2 Description of Proposed Action and Alternatives, Revised

This chapter describes the specific elements of the new alternative (Alternative 3). It includes revisions to the project description; modifications to the location, timing, and type of activities; and changes in certain design elements. All revised figures are provided at the end of the chapter.

R-9 Cross Section

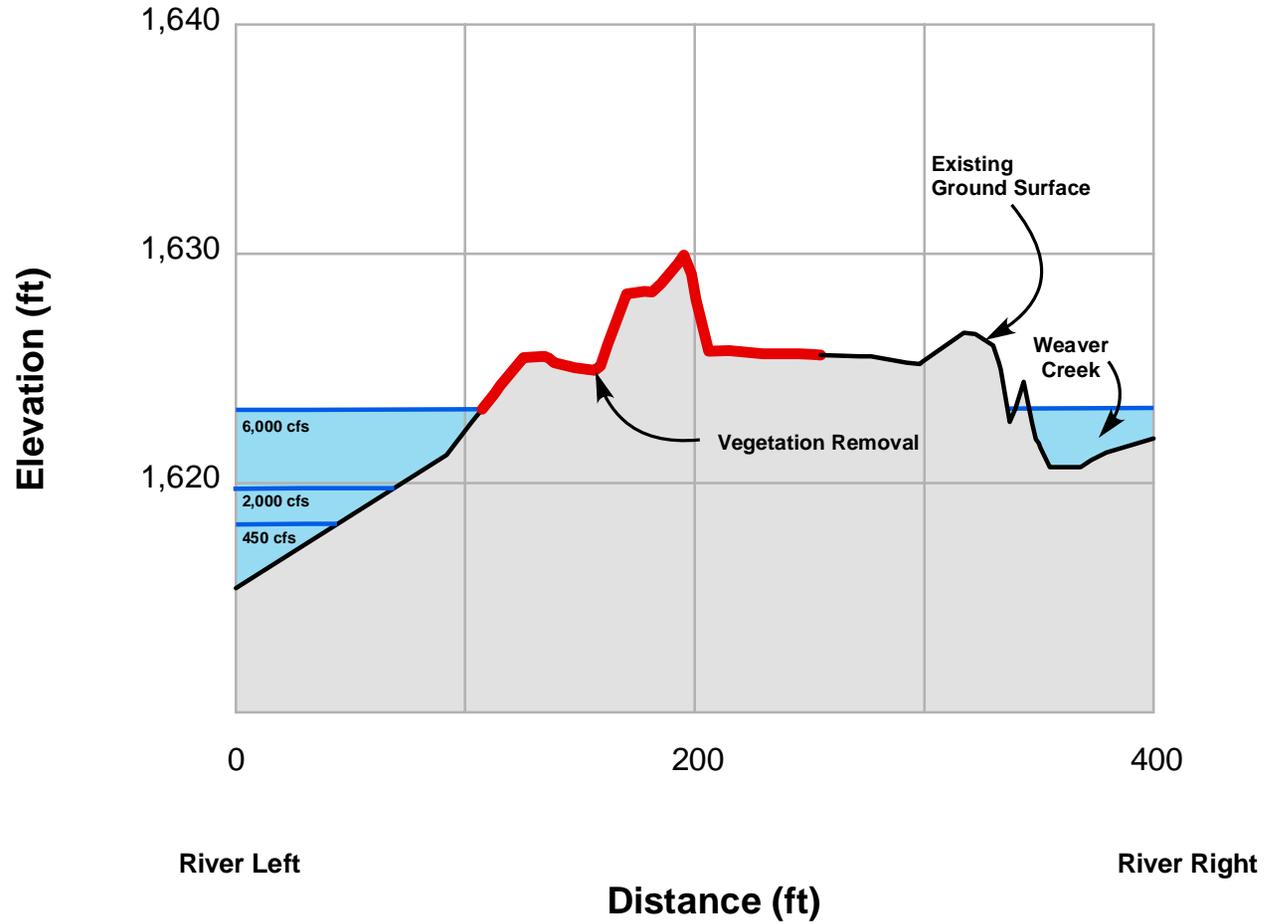
- R-9. The level of activity in this area has been reduced because geomorphic changes will continue to occur at the mouth of Weaver Creek regardless of the activity. Under this alternative, vegetation removal would occur at this area; however, no excavation of alluvial material is proposed. As materials are transported off-site each year, contouring and floodplain functionality would be maintained. Revised Figure 2.5i illustrates the modified activities at this area.
- R-10. No Change.

T-1, T-2 and U-3 Cross Sections

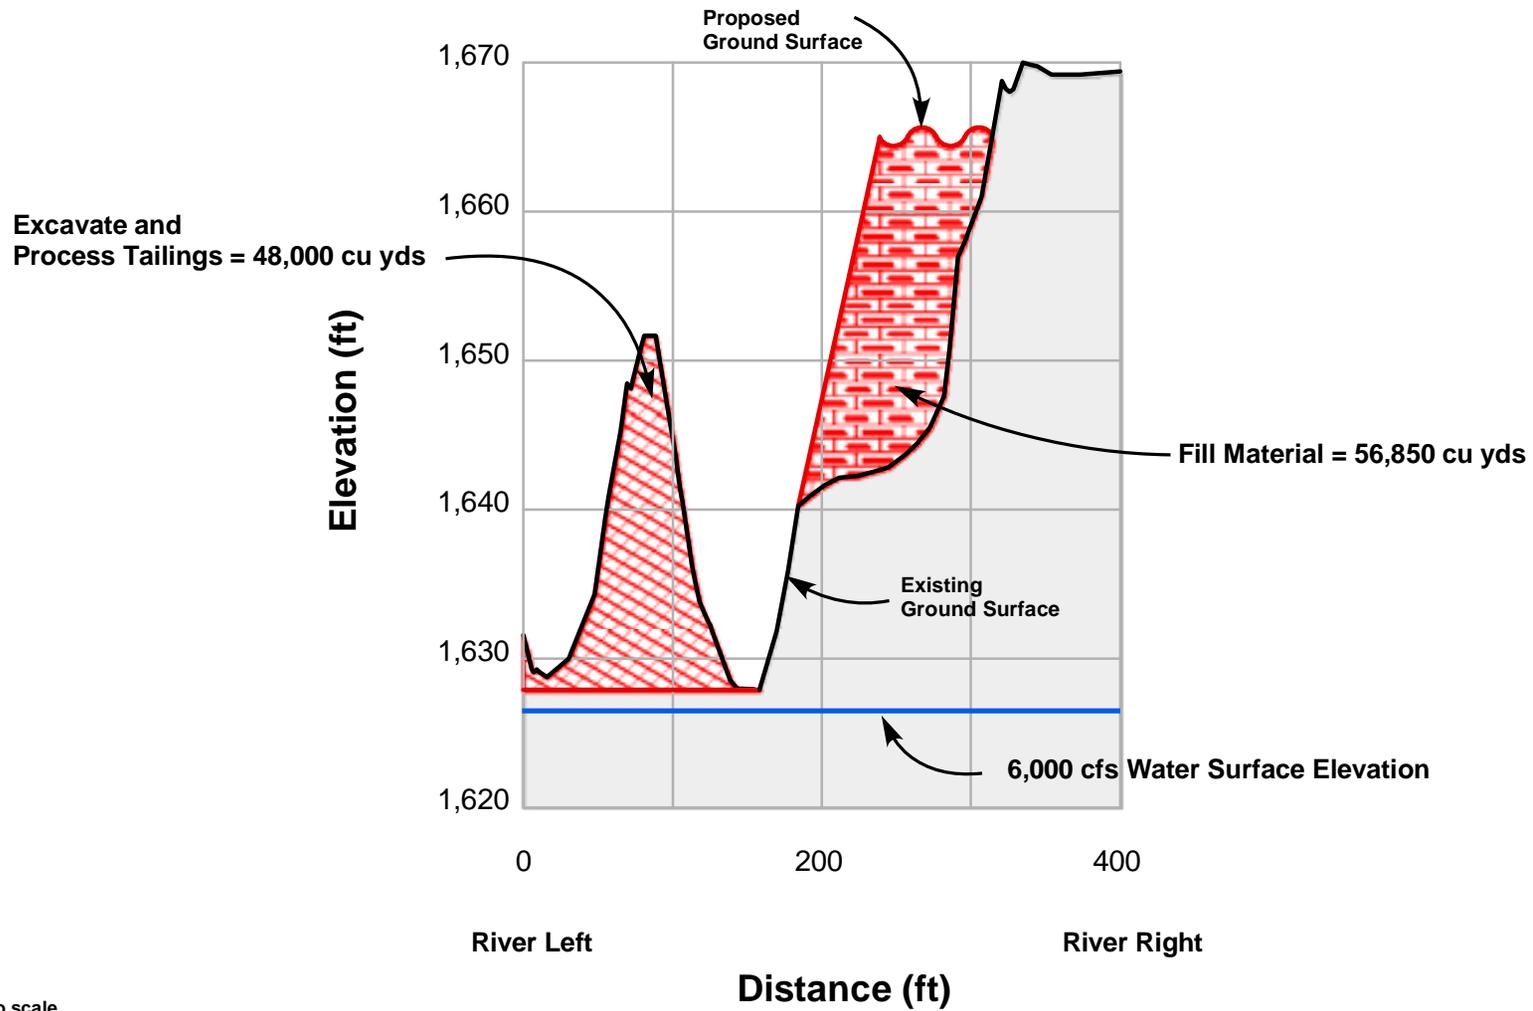
- T-1. This area encompasses dredge tailing deposits located between R-8 and U-3. These deposits could provide a source of alluvial material suitable for gravel enhancement projects proposed for the Trinity River in conjunction with the TRRP. Material excavated from this activity area would be processed and transported within 5 years to suitable off-site locations for use in future riverine rehabilitation projects. Figure 2.6c illustrates the location and maximum extent of excavation proposed for activity areas T1 and T2.

- U-3. The size of this activity area has been slightly reduced under Alternative 3. The amount of material that may be disposed of on-site would be reduced in proportion to the amount of material that would be excavated from R-8, T-1, and T-2. Revised Figure 2.6c illustrates the overall reduction in alluvial material that could be disposed of at this location.

Figure 2.9
X-3 Cross Section Profile of Proposed Weaver Creek Crossing

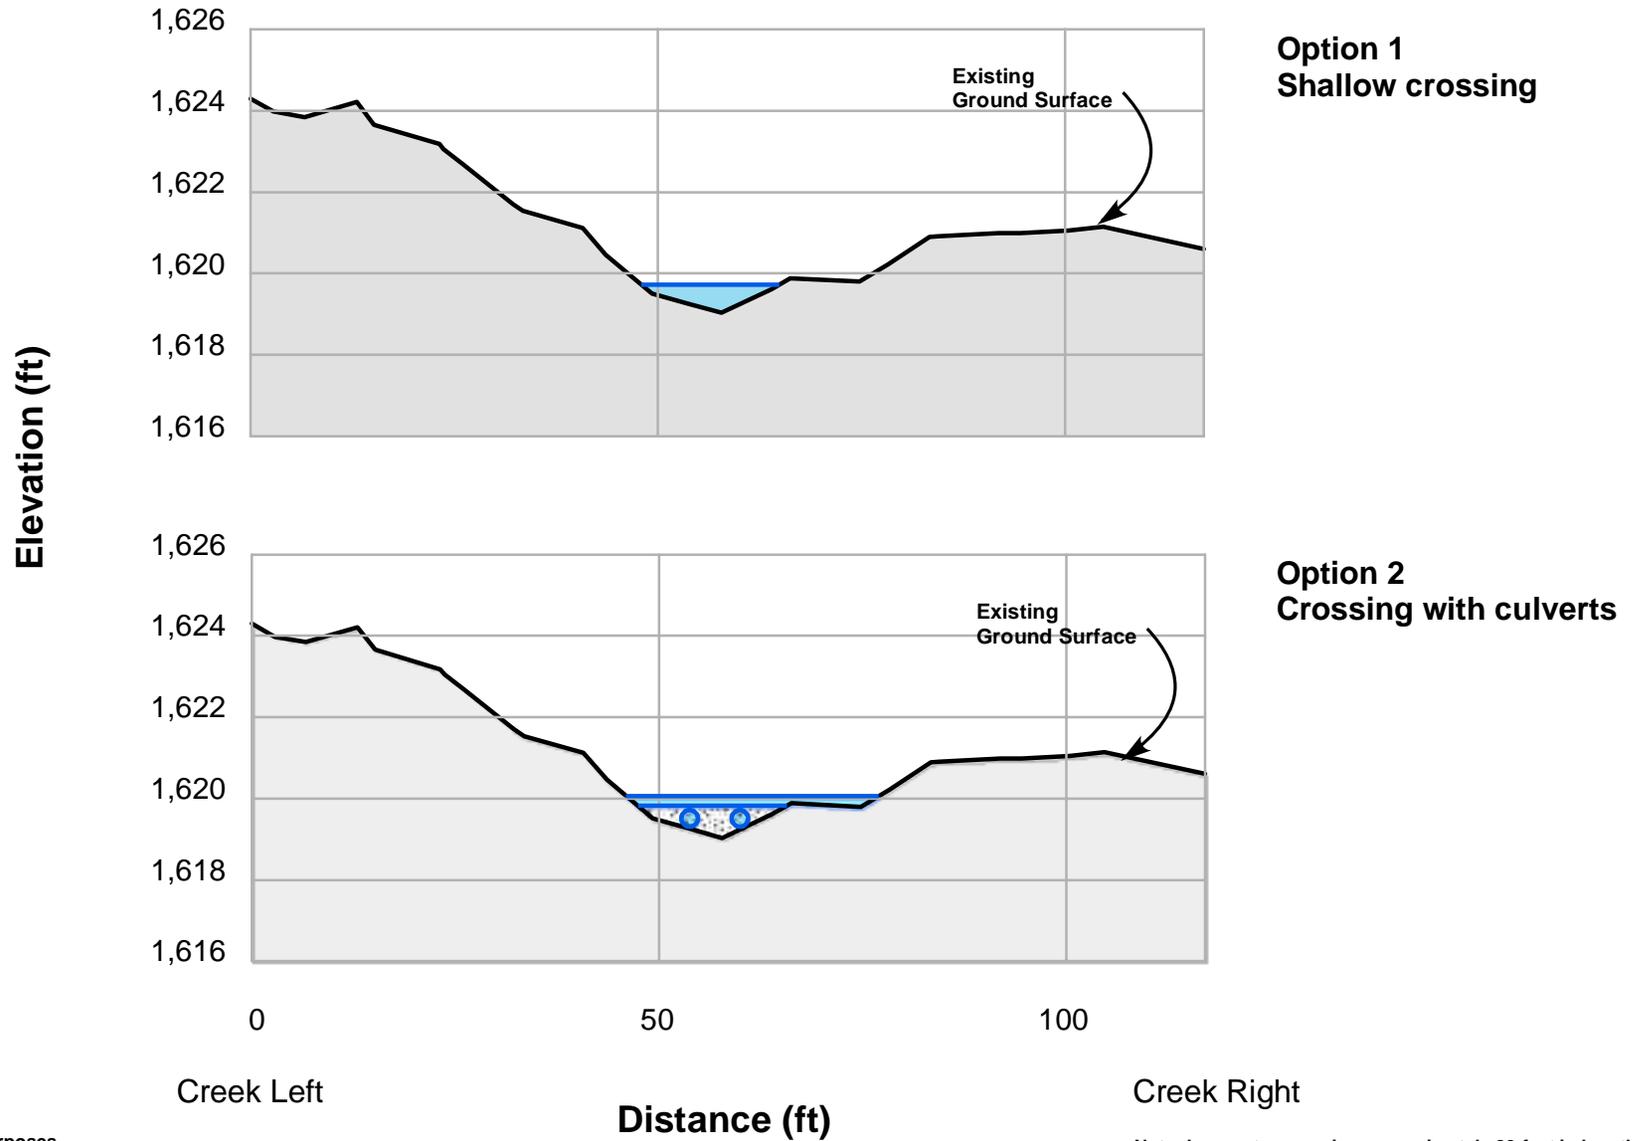
- X-3 – Alternative Weaver Creek Crossing. Vehicular traffic will require a crossing of Weaver Creek in order to access activity areas R-8, R-9, R-10, U-3, T-1, and T-2. The crossing will be built concurrently with the reconstruction of the access road. Figure 2.9 illustrates several options that could be used for this crossing.
